THE NORTH SANTA MONICA BOULEVARD RECONSTRUCTION PROJECT
CITY OF BEVERLY HILLS
BID ADDENDUM NO. 5

ADDENDUM NO. 5 for the above referenced project hereby modifies the bid documents, as follows:

RFI 51

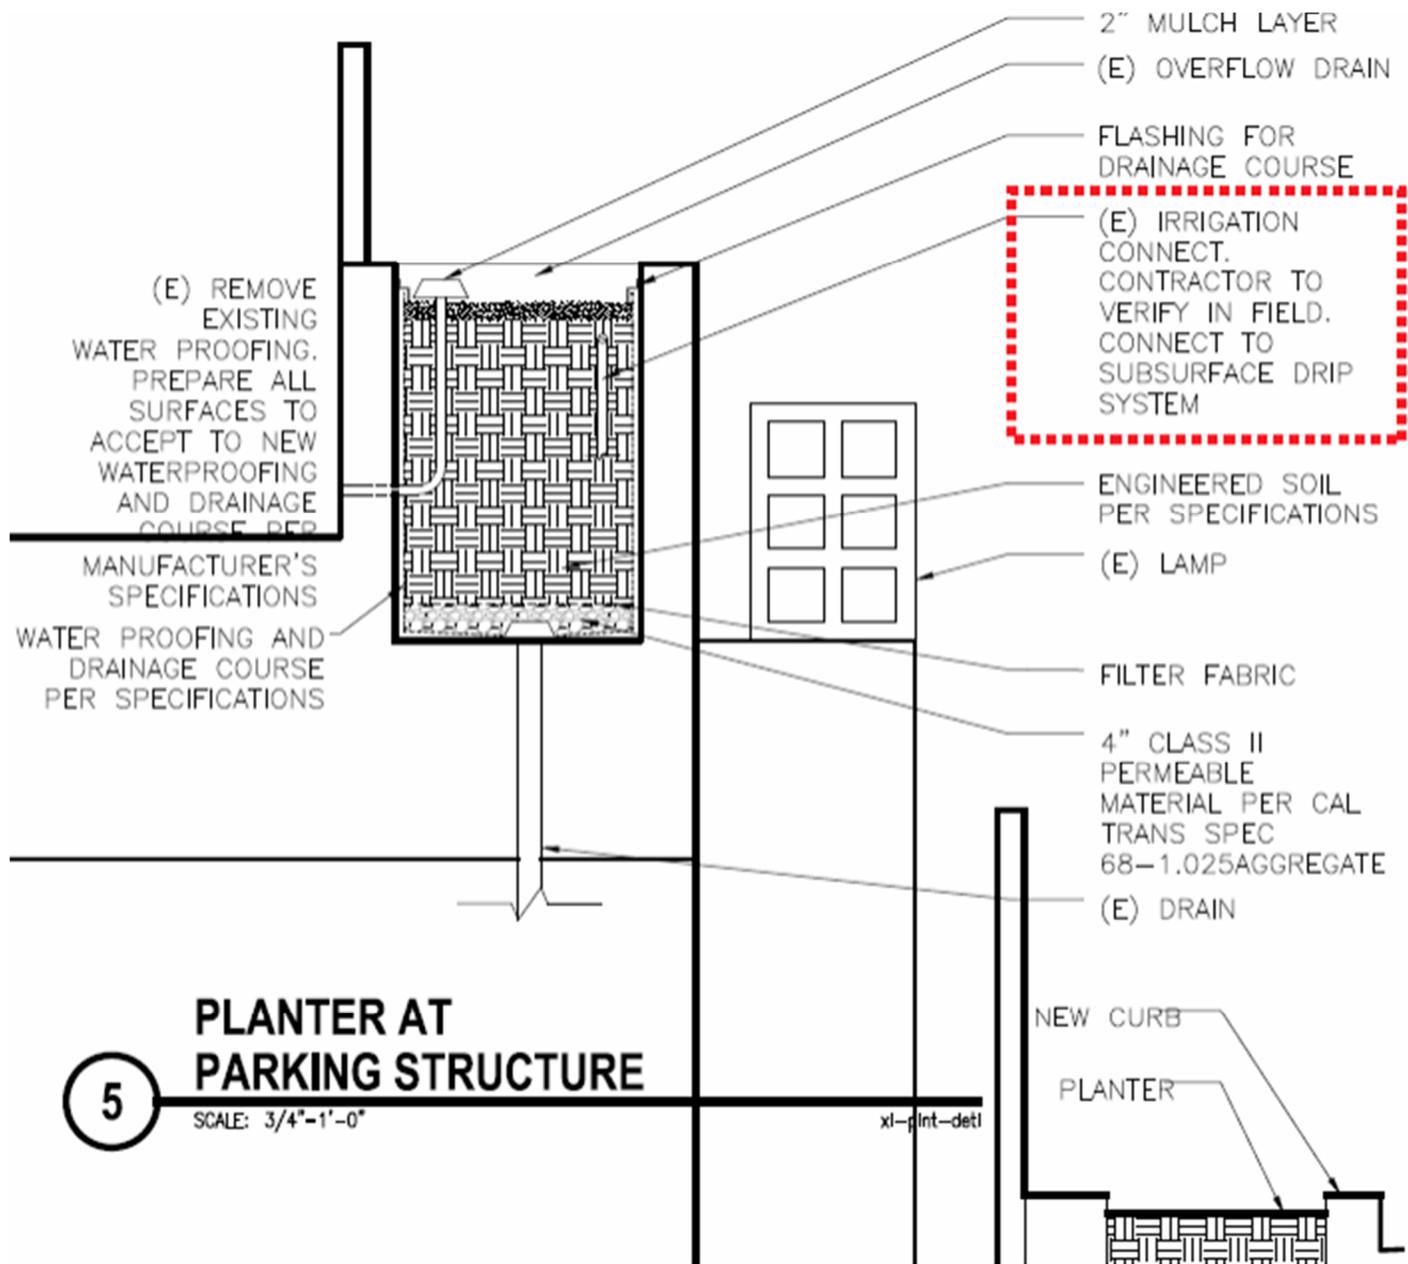
1. The irrigation shown on page 67 through 71 of 85 shows irrigation Netafim tubing to be installed through the existing parking structure to the planters. Please advise how this line is to be installed. The planters are on the 2nd story of the existing parking structure and the tubing is shown across the parking structure.

All equipment shown on plans is diagrammatic.
Typical Note below on all irrigation plans.

NOTE C:
MAINLINE AND RELATED EQUIPMENT
SHOWN WITHIN PAVING FOR CLARITY
ONLY, ACTUAL MAINLINE AND RELATED
EQUIPMENT LOCATION TO BE WITHIN
PLANTERS AND A MINIMUM OF 18" OFF
ADJACENT HARDSCAPE AND OTHER
OBSTACLES TYP.

Based on site observation of the planters, there appeared to be operable water service to each planter. Contractor should existing irrigation system mainline. Contractor to verify in field. To note, per visual observation, existing mainline was not observed to be hanging / attached from the ceiling in the parking structure or along the outside of the structure, though it may have been a location that was not accessible at the time of the field observation. Irrigation mainline may also already be embedded in concrete or in sleeve in concrete.

The City does not expect contractor to break apart concrete to install a new mainline. New irrigation mainline or laterals that serve the planters may be attached to the ceiling or on the outside of the parking, per direction from the city. Please check with David Garrard, City of Beverly Hills.

All equipment and mainline in hardscape shown for clarity only. Depending on built conditions and new design, valve may be installed in landscape areas (preferred) or in planter on second floor.

Contractor to verify location and operability of existing irrigation mainline and connects to planters.
